Request for Revision of Monitoring Plan

"Ganluo Kaijianqiao Hydropower Project, P.R.China" (1432)

Validation opinion as per requirement of EB26, Annex 34, para 5

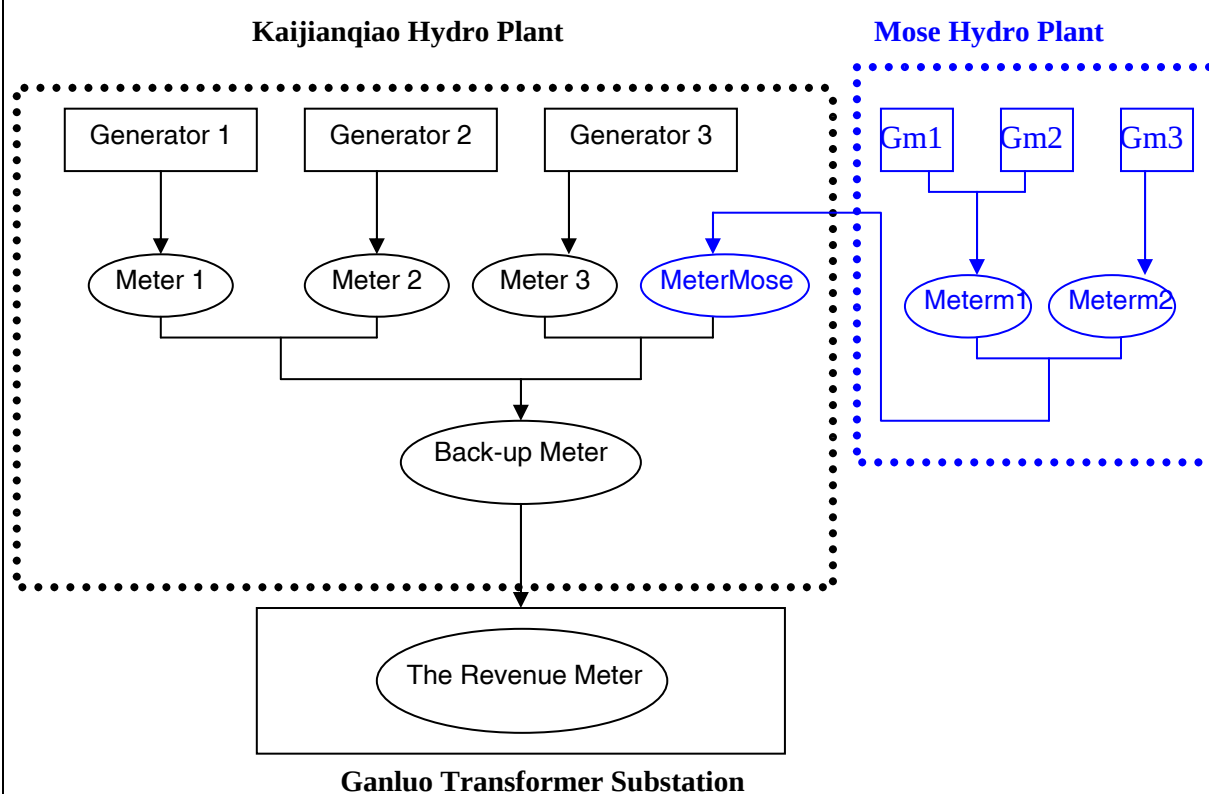
In comparison to the registered PDD the key changes in the revised monitoring plan are presented below:

Deviant to the project situation as explained in section B.7. of the registered PDD, the electricity measurement of the project activity consists of a joint meter reading with another hydro project named Mose Hydro Plant. The electricity transmission line is connected to the CDM project and the electricity is jointly feed to the grid.

Considering this situation the project participants revised the monitoring plan including additional parameters to be monitored. The drawing included in the revised monitoring section of the PDD gives an overview of the project activity and the transmission line connections:

The parameter EG_y cannot be directly measured, rather it has to be calculated due to the addition of

other operating hydro power plant connected to the common metering point.

The proposed revised monitoring plan content in the revised PDD ensures that the level of accuracy and completeness has improved as compared to the monitoring plan of registered PDD.
